GLYCOL WATER  
FLOW DIAGRAM  
OPERATIONS SUPPORT FACILITY

DWG. NO. 302-834 SHEET REV. N/A 6

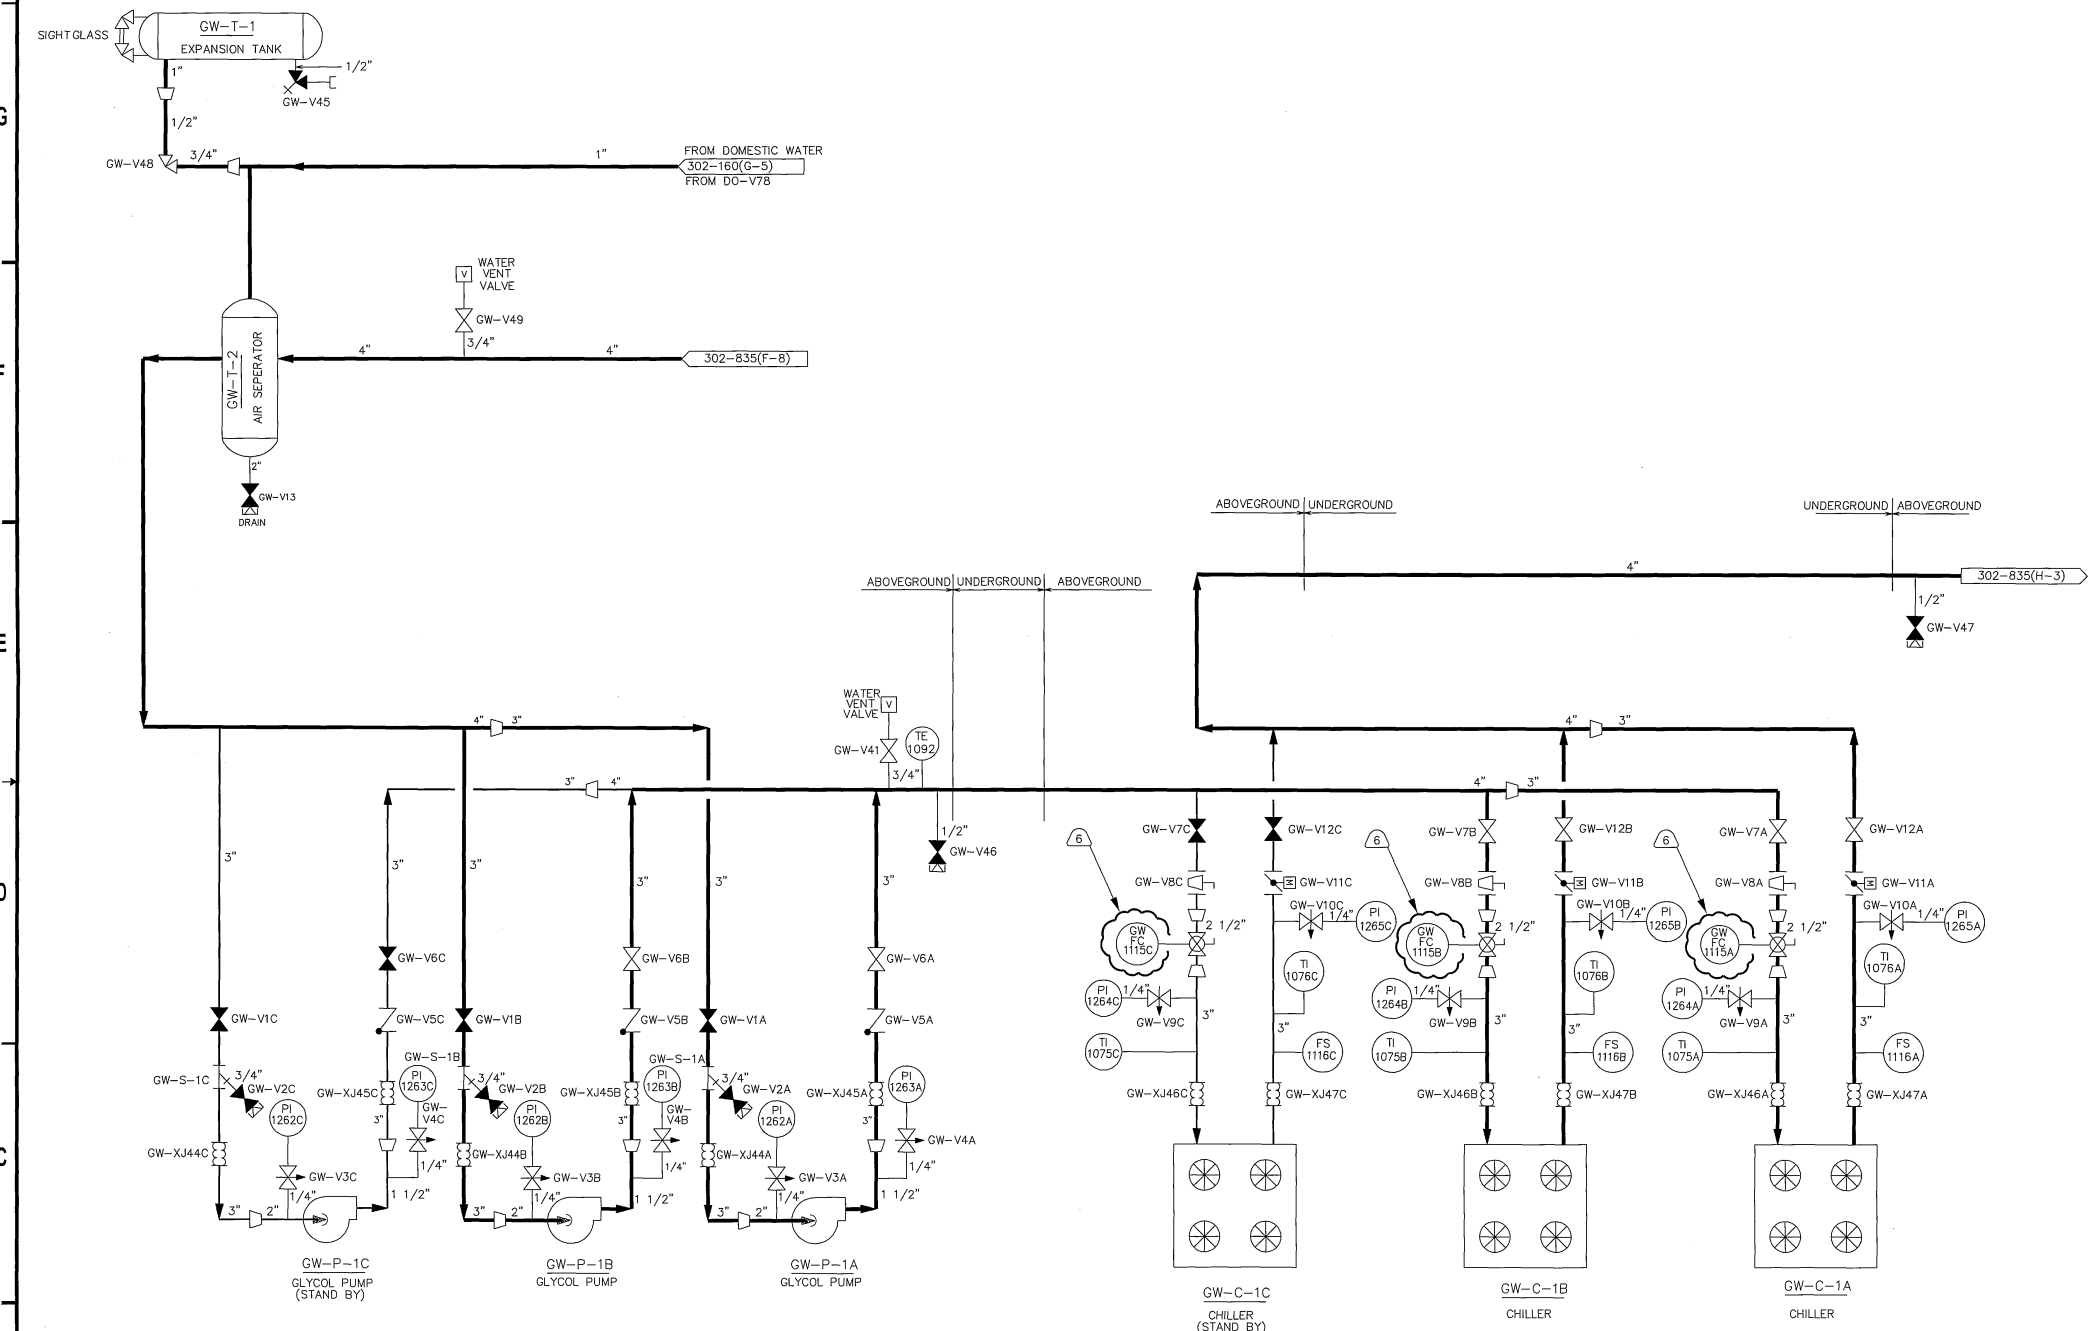
REVISIONS		
REV	ZONE	DESCRIPTION
6	VARIABLES	ADMINISTRATIVE REV. TO CORRECT EDITORIAL ERROR. CHANGED AHI-FC-1115A/C TO READ AS GW-FC-1115A/C. (REF AR 02472901)
